**Subject:** VTA Information: EBRC Third Addendum to the Final Second Supplemental EIR

# **Eastridge to BART Regional Connector**

## **Third Addendum to the Final Second Supplemental Environmental Impact Report**

**February 2021**

|   | TREE EXHIBIT              | DATE: 12/09/2020<br>SHEET 1 OF 3 |

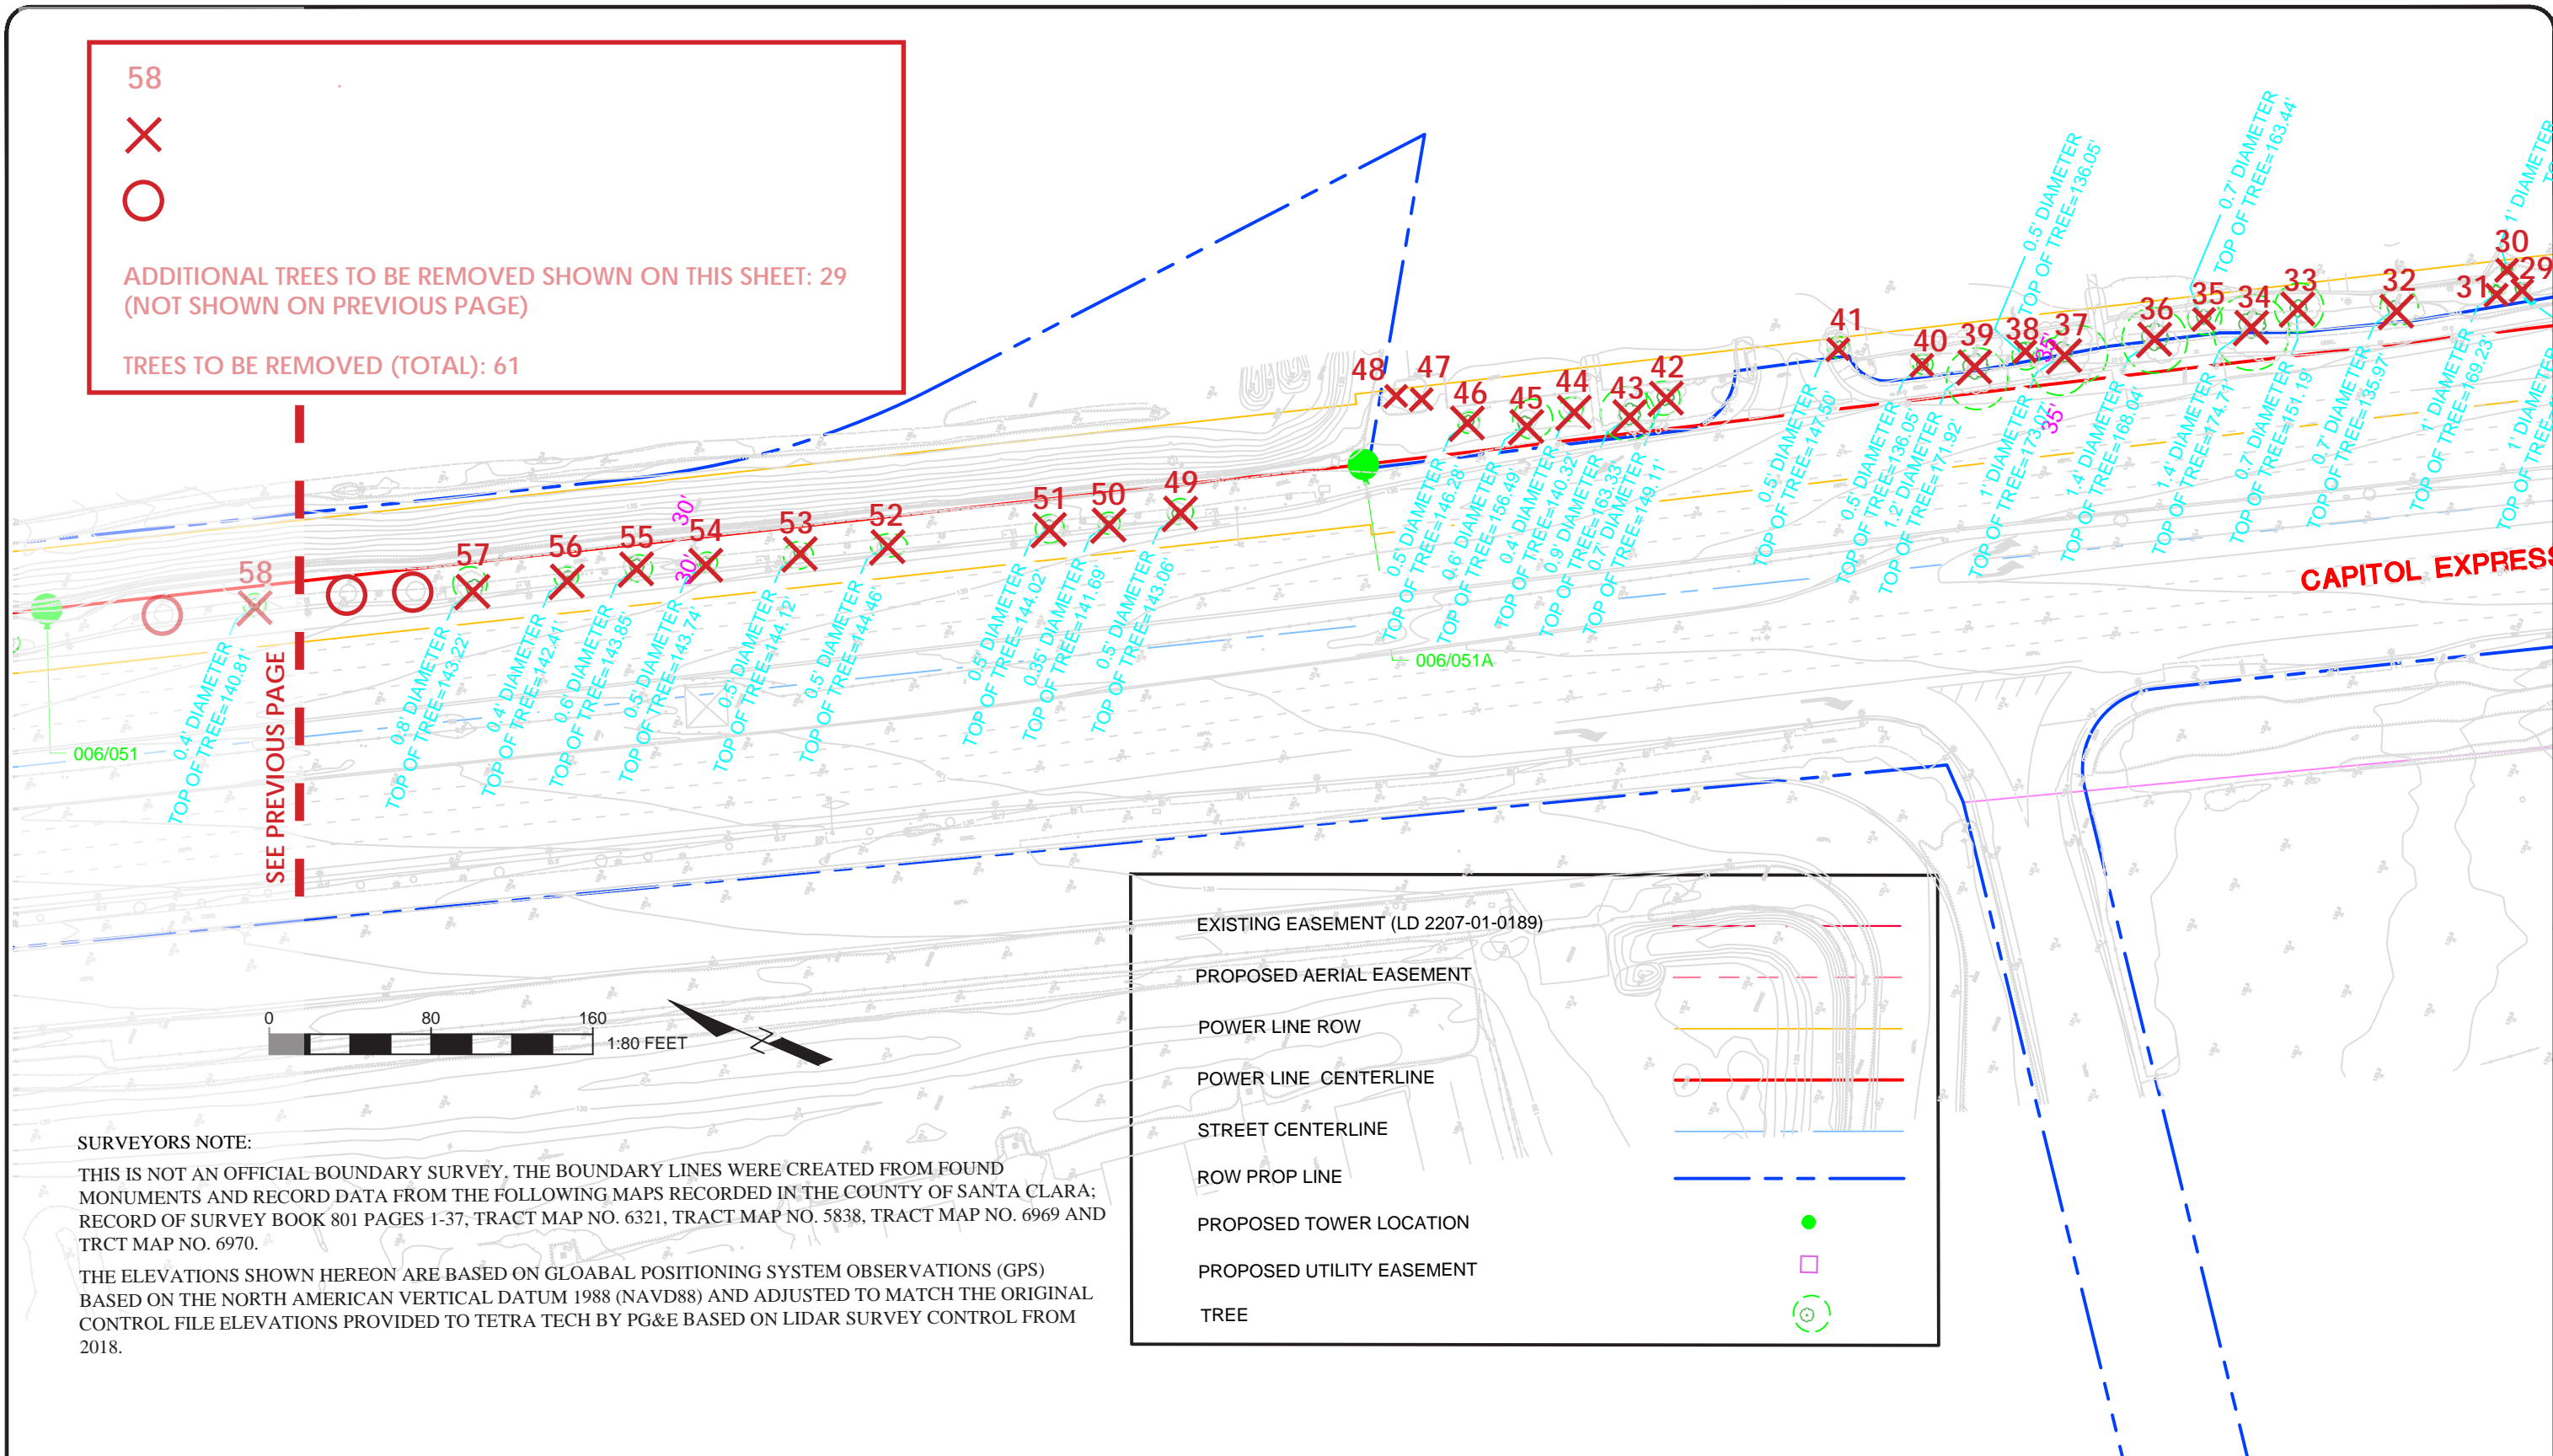
58 TREE NUMBER, SEE SPREADSHEET  
 X TREE TO BE REMOVED  
 O EMPTY TREE WELL  
 TREES TO BE REMOVED SHOWN ON THIS SHEET: 14  
 TREES TO BE REMOVED (TOTAL): 61

|                                      |   | SHEET 2 OF 3     |

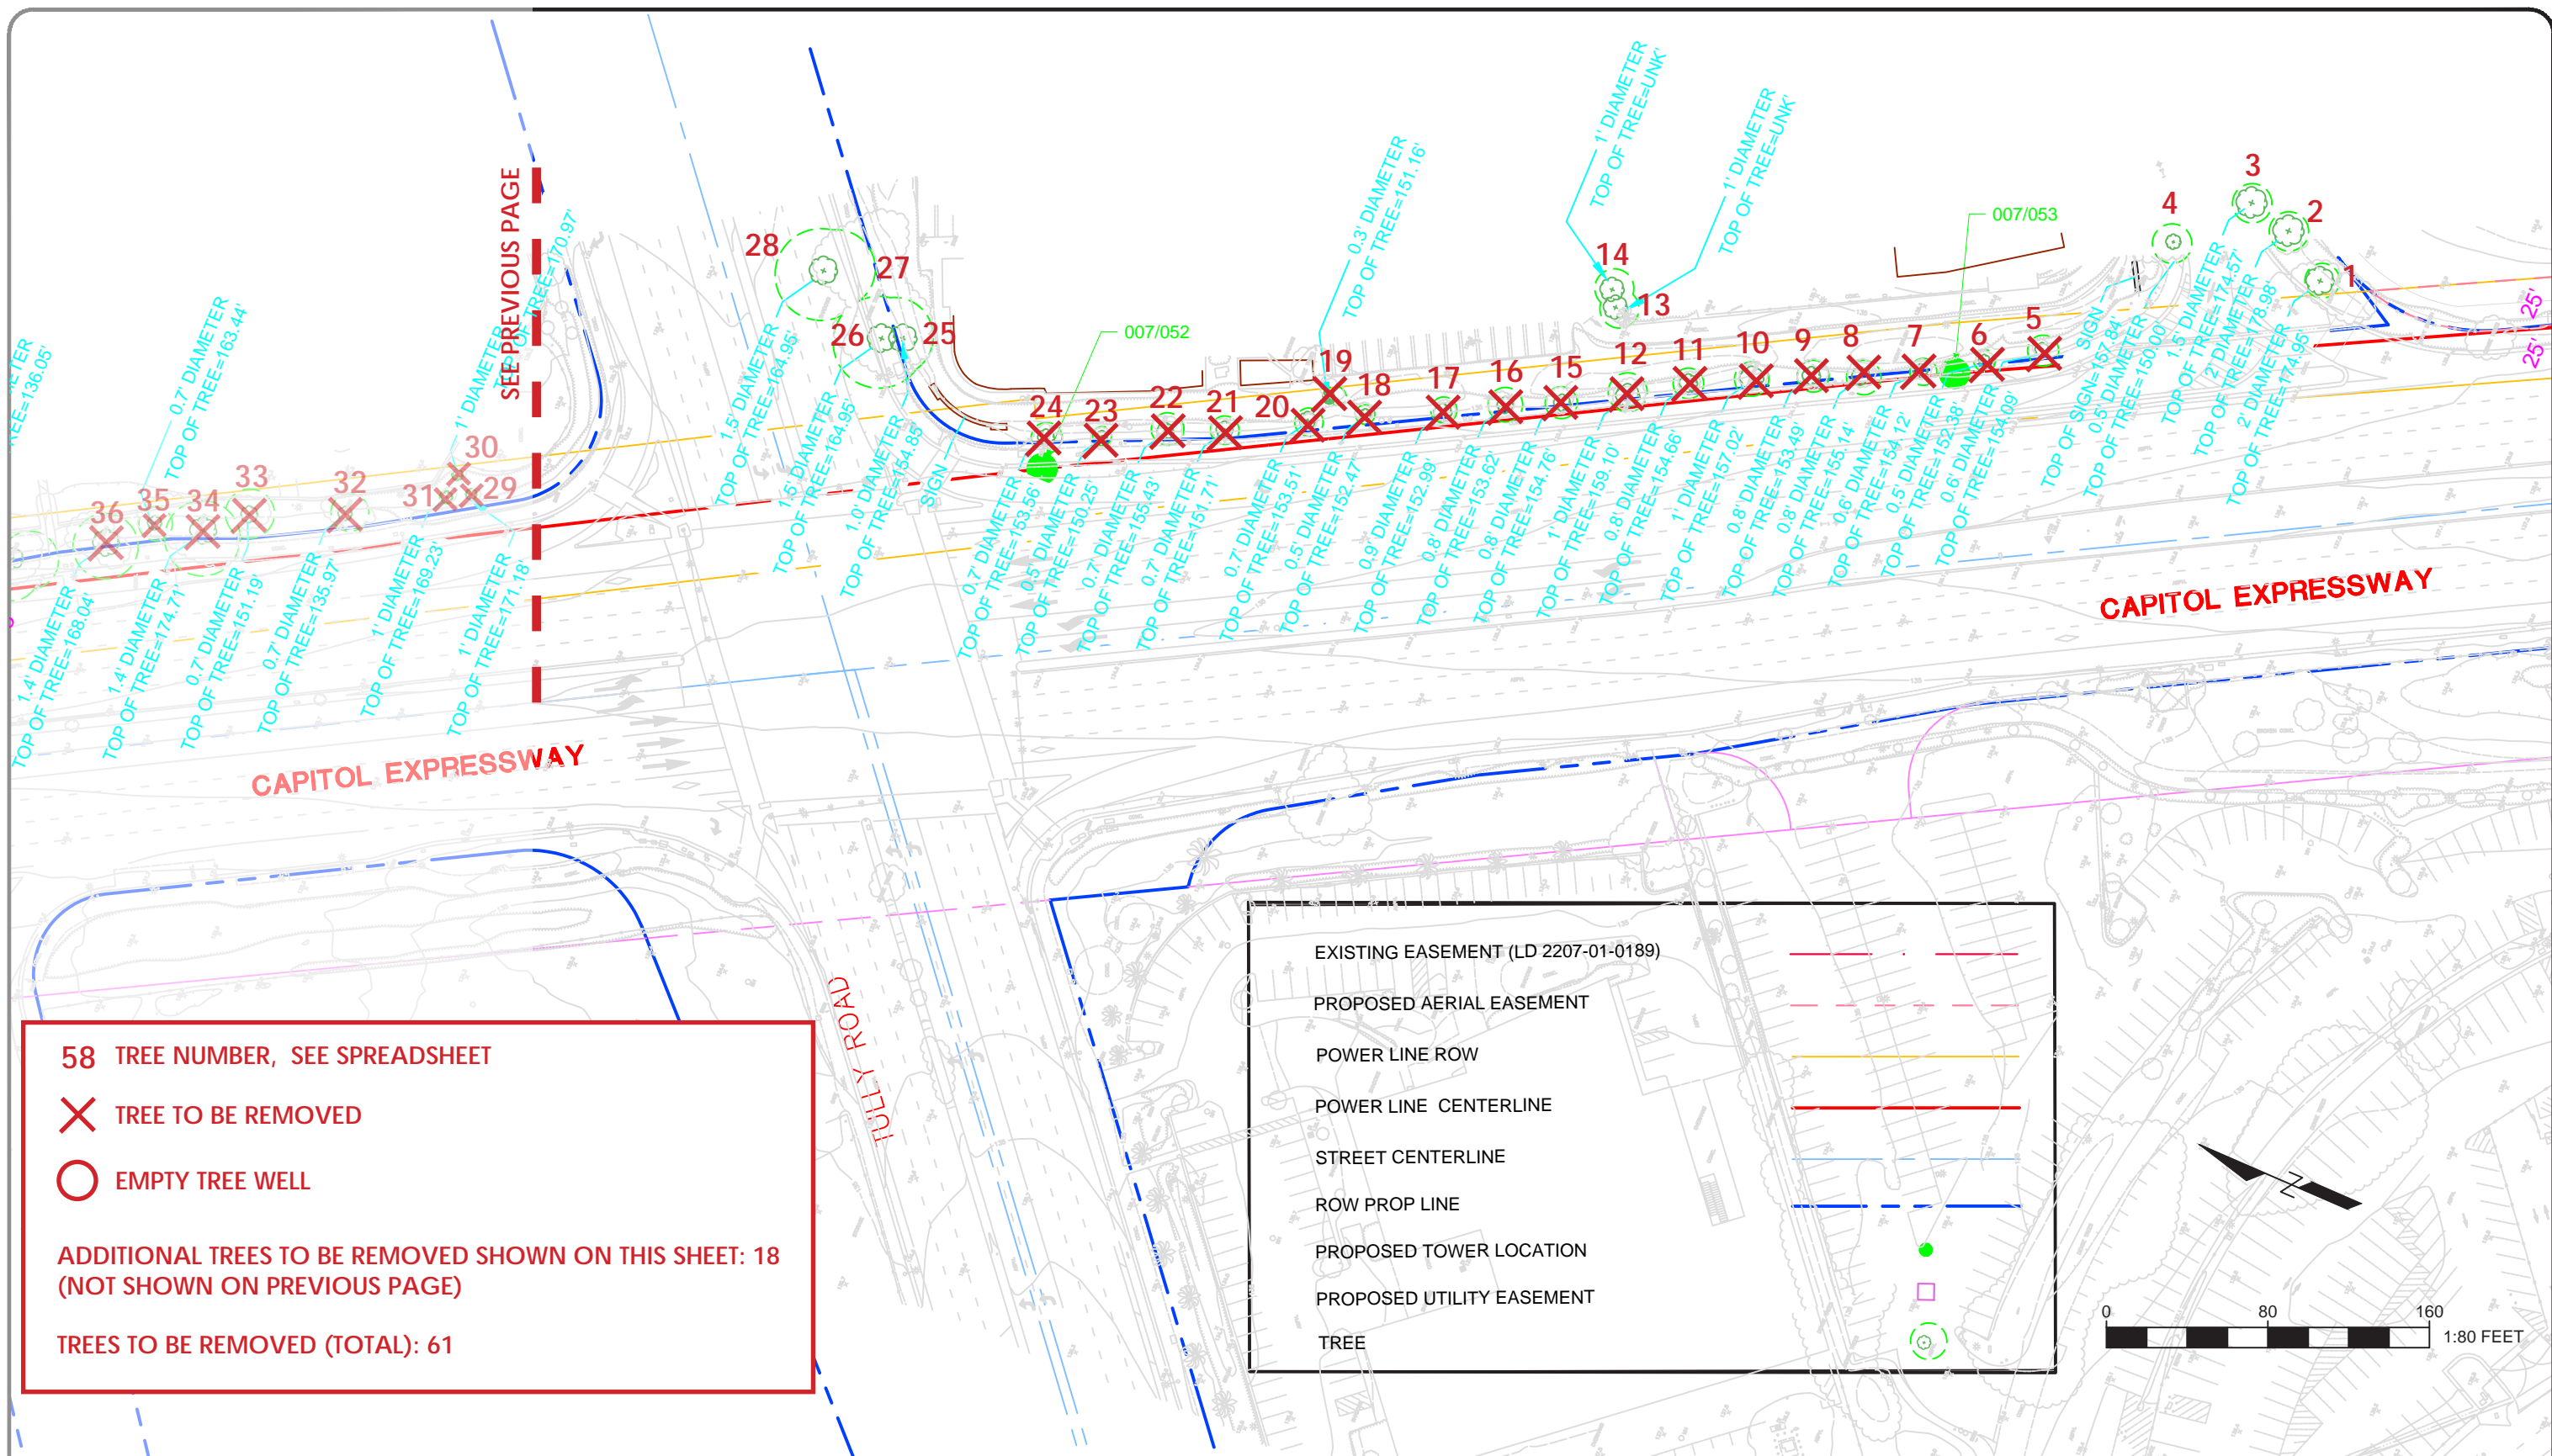
ADDITIONAL TREES TO BE REMOVED SHOWN ON THIS SHEET: 29  
 (NOT SHOWN ON PREVIOUS PAGE)
